MIL-F-16377/6A(SH)
AMENDMENT 2
2 August 1996

MILITARY SPECIFICATION SHEET

FIXTURES, LIGHTING; FLUORESCENT, GENERAL LIGHTING, DIRECTIONAL 16 WATTS, 120 VOLTS, 60 HERTZ, WATERTIGHT, SYMBOLS 149.4 AND 149.5

FIGURE 6. Wiring diagram.

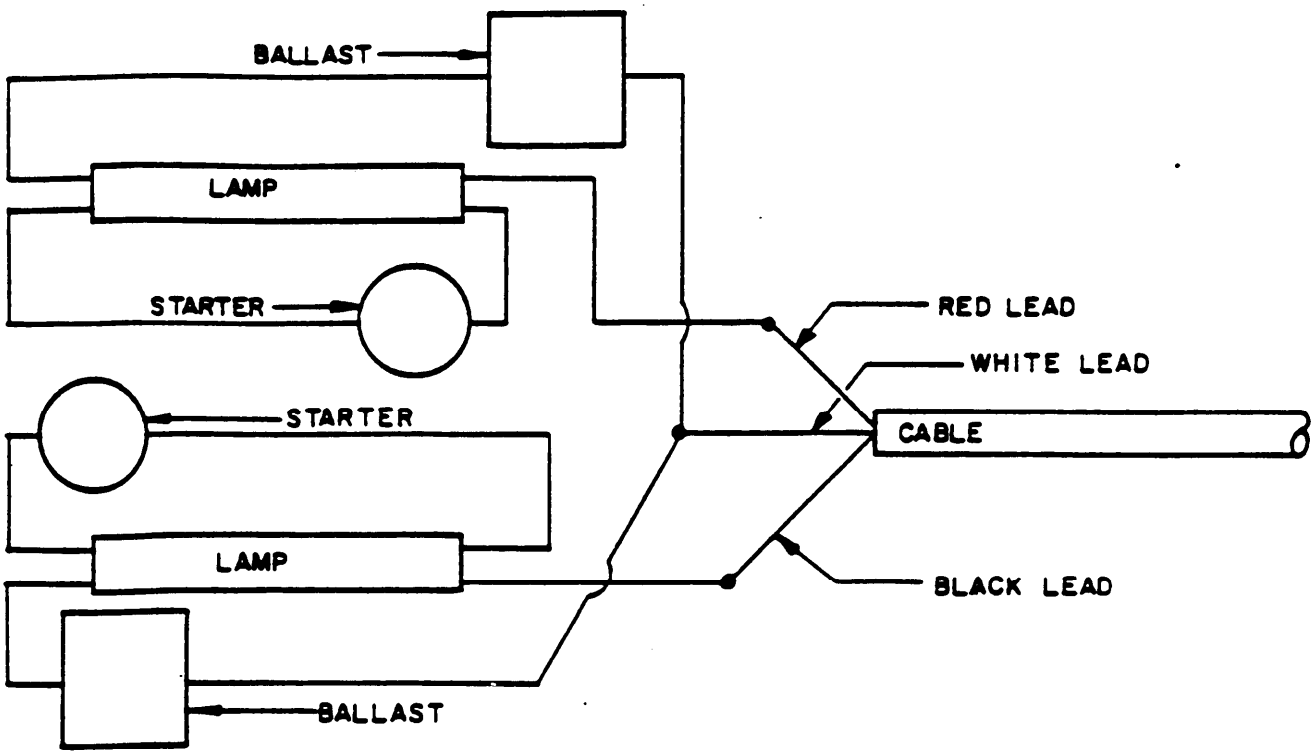
* The attached insertable pages are new pages. When the new pages have been entered in the document, insert the amendment as the cover sheet to the specification.

Page 4a/4b.
